ADDENDUM No. 2

LINK – Multi-Use Development

BID PACKAGE – All Trades

April 17, 2023

A101.1

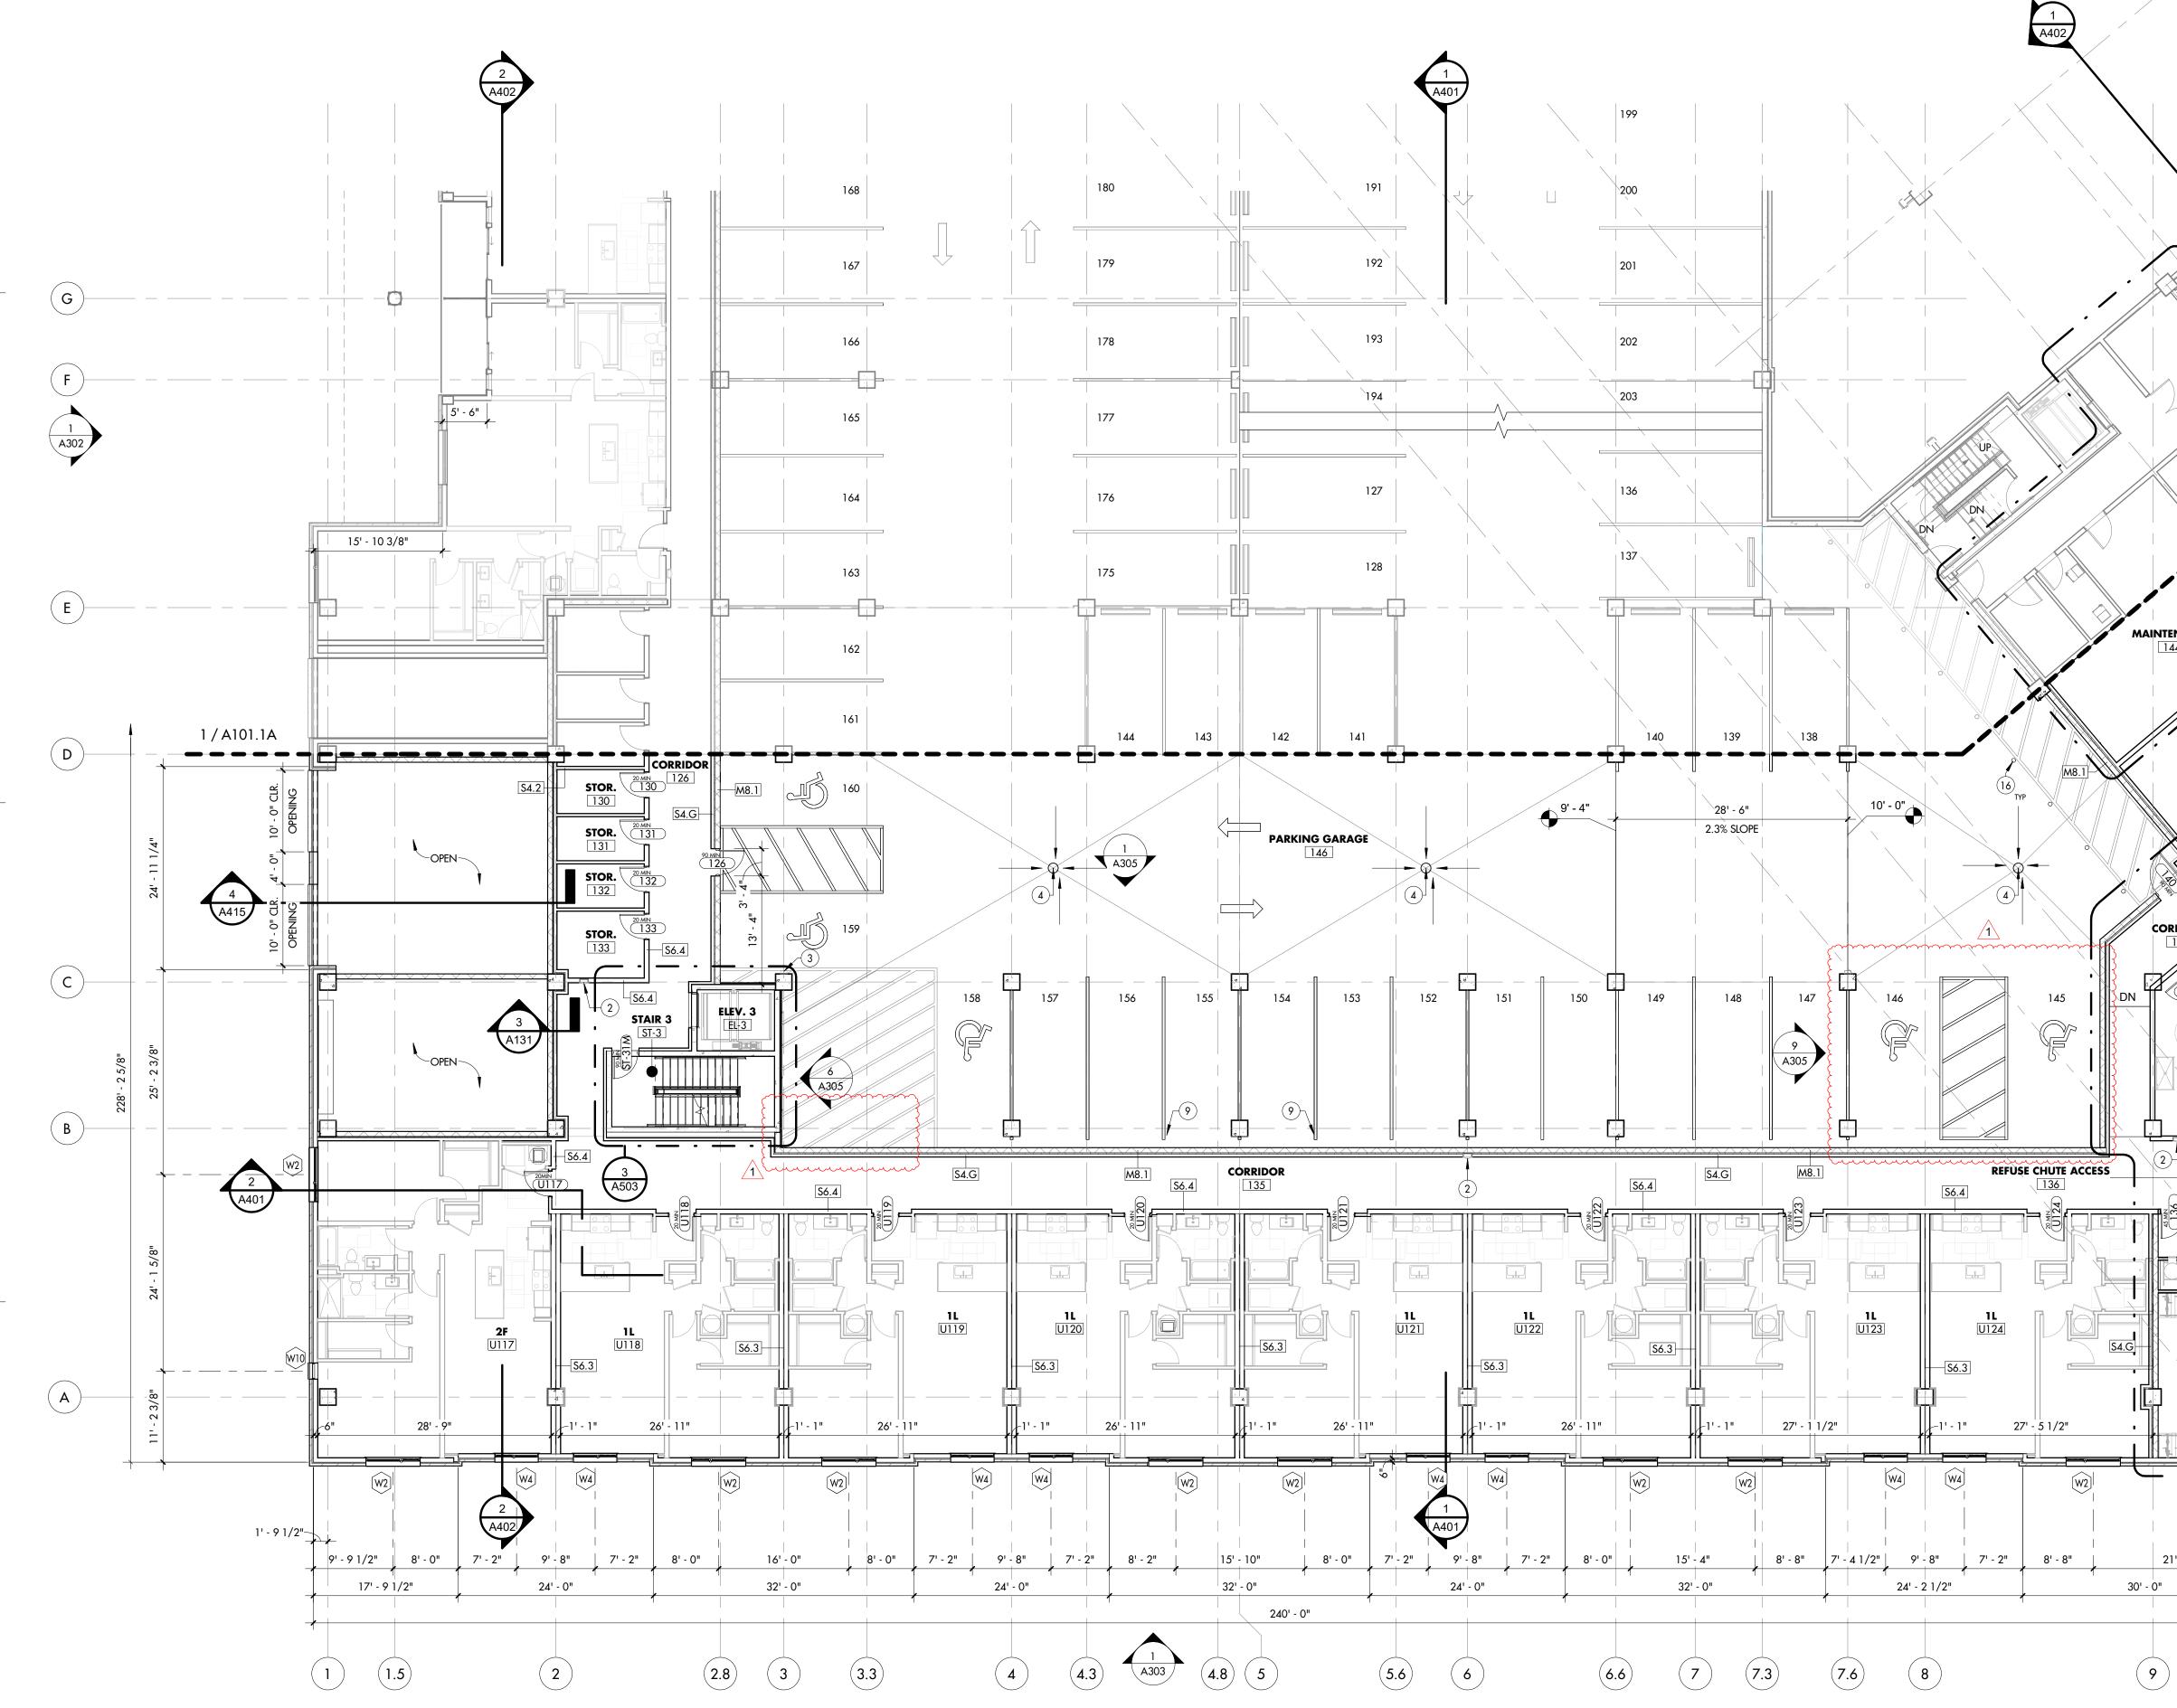
- o A001
 - Revised shaft wall note "a" to read (2) layers of 5/8" type 'X' gyp board.
- o A101.1
 - Revised parking. Added (2) ADA spaces.
 - Delete Door 135.

# REVISION DATE
	1 Addendum #2 4/14/23
_	
_	
	S
	VENUE IN 4620
	VALL SECTION LINK - UNK 921 VIRGINIA AVENUE 921 VIRGINIA AVENUE INDIANAPOLIS, IN 46203
	100% CONSTRUCTION DOCUMENTS 4/4/23
SECTIONS ARE	
<u>-O"</u> TYPICAL.	A413

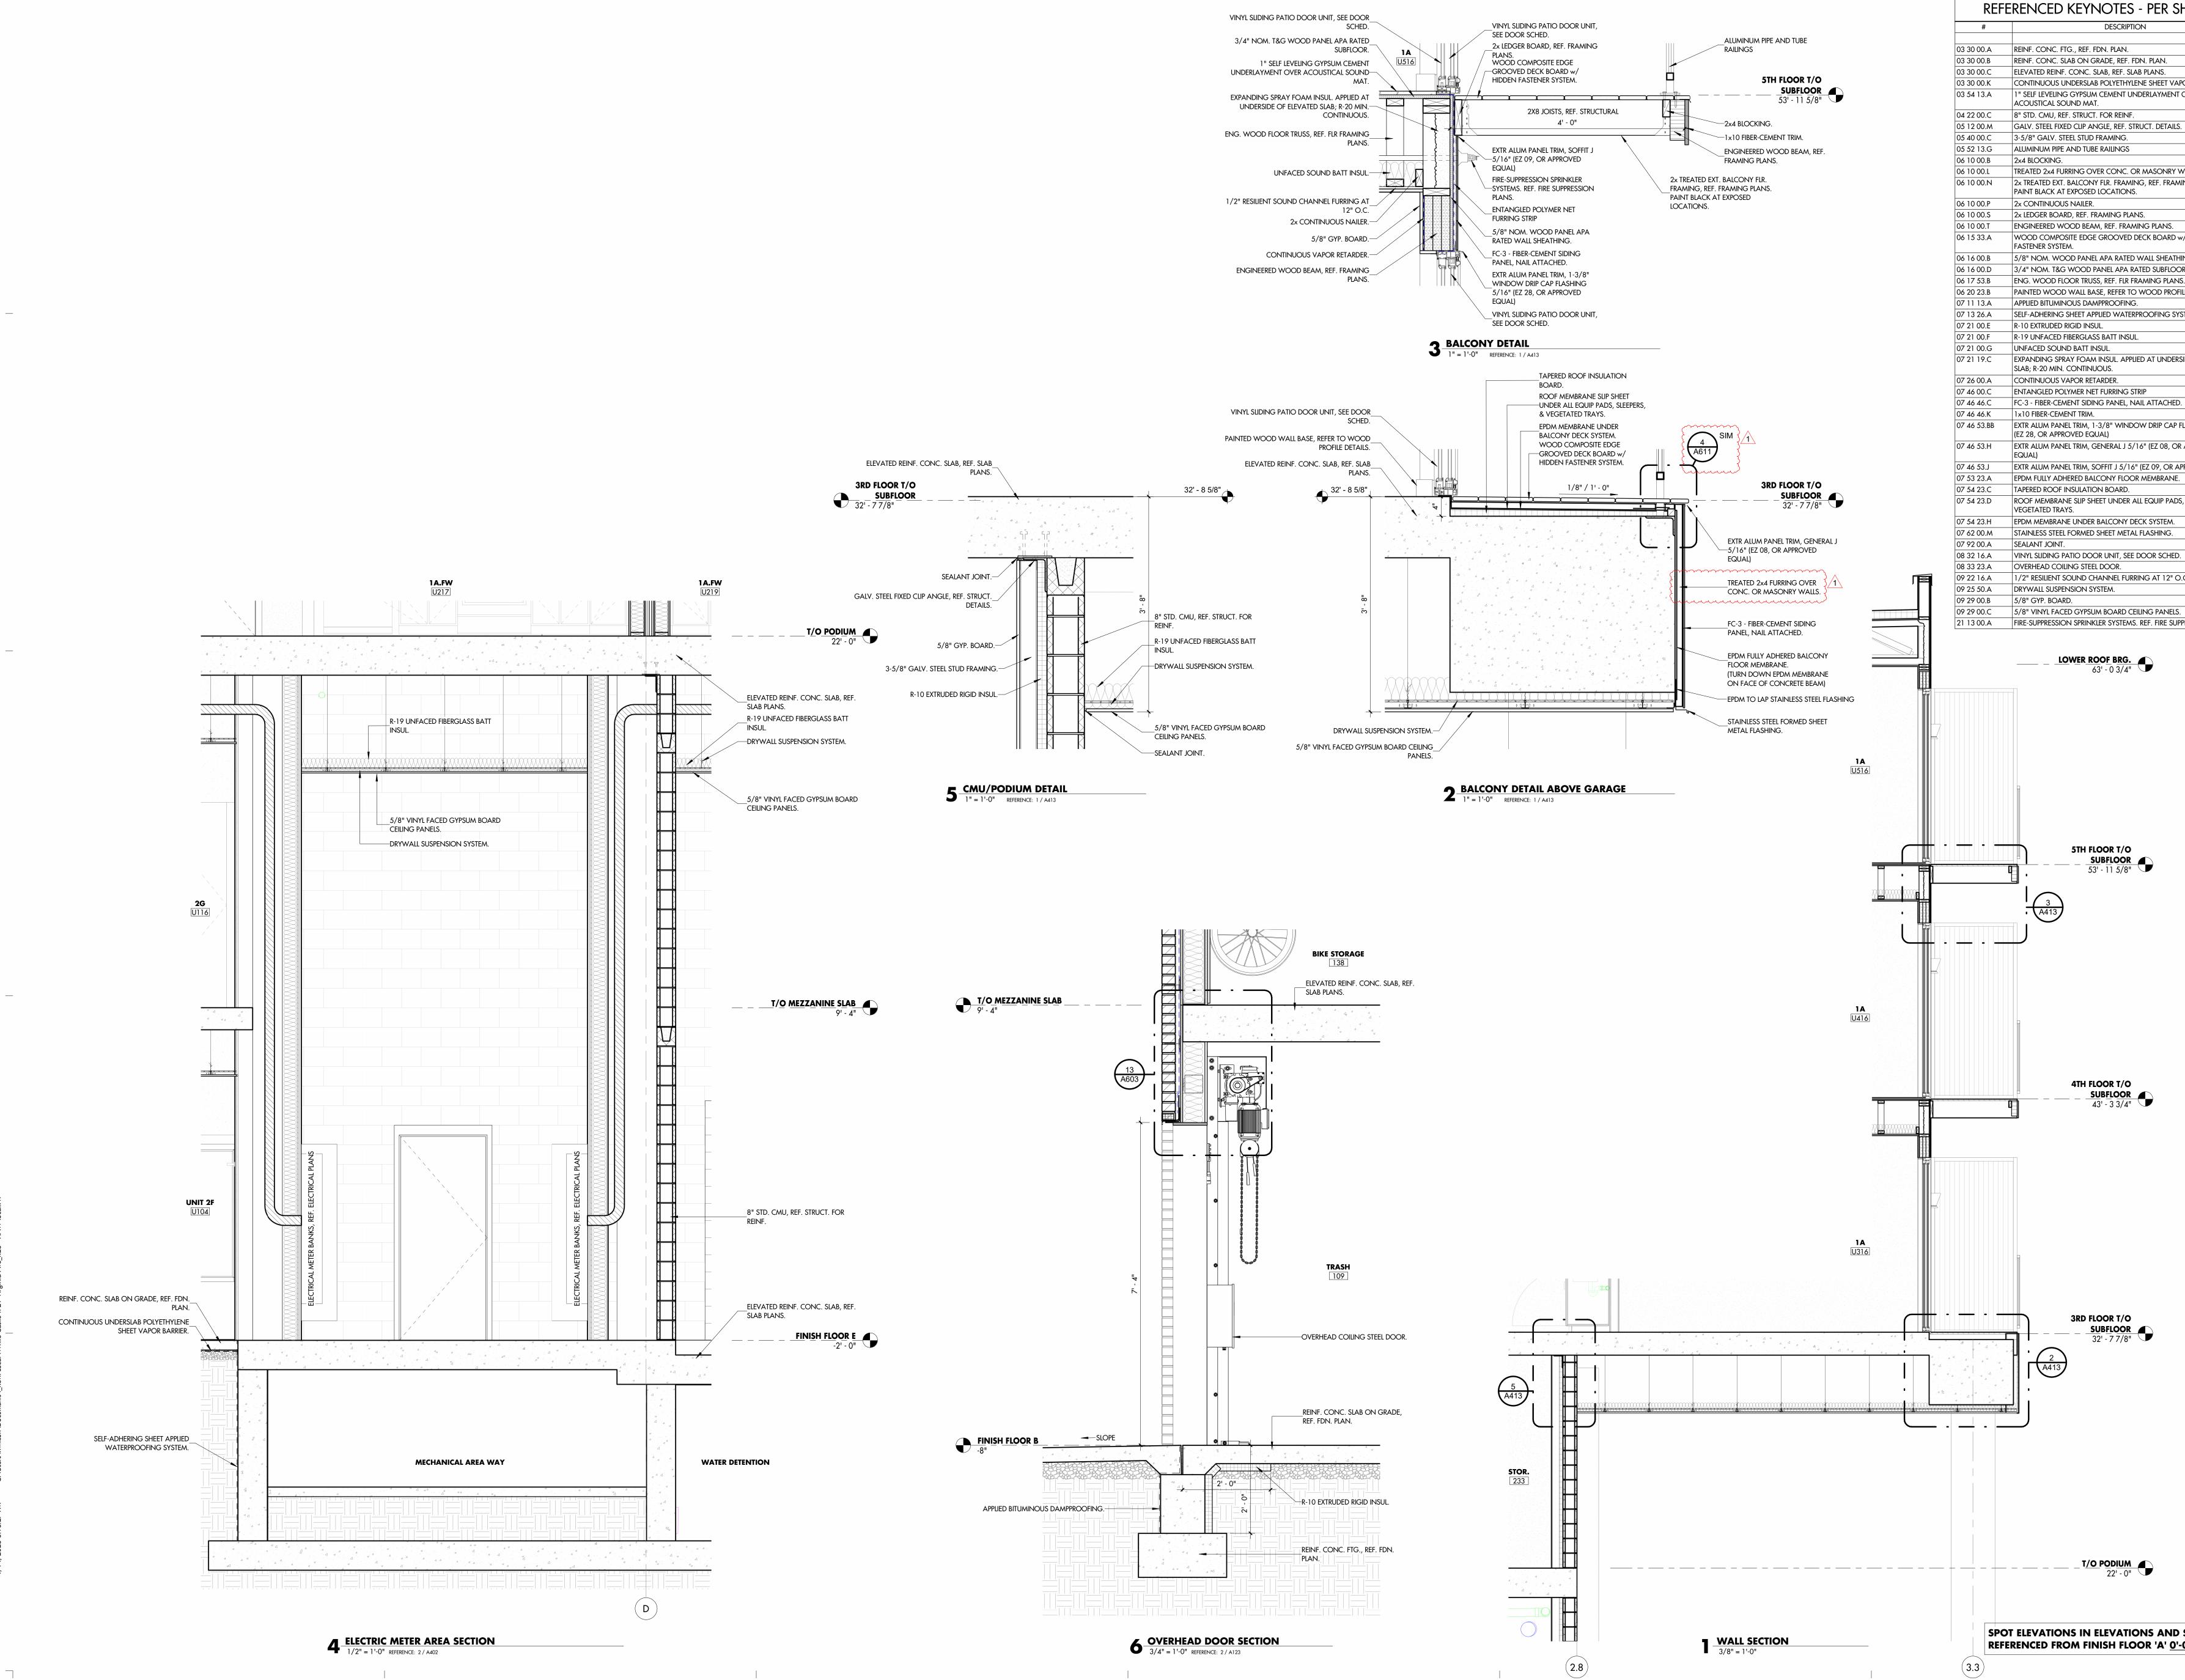
- o A413
 - 2/A413
 - Added railing detail reference.
 - Add missing furring note.
- o A419
 - 5/A419
 - Added balcony detail information.
 - 7/A419
 - Added sheathing and insulation detail information.
- o A422
 - Add railing information.
- o A423
 - Revise Refuse Chute and Mechanical Shaft wall construction between Mezzanine slab and 2nd floor slab to metal shaft wall framing system.
- o A611
 - Detail 5 revised.
 - Detail 9 delete damp proofing note.
- o A700
 - Add 'WD2' to finish legend.
- o A802
 - Clarified tackboard 'by owner'.
- o A804
 - Add paint note.
 - Add exposed concrete column note.
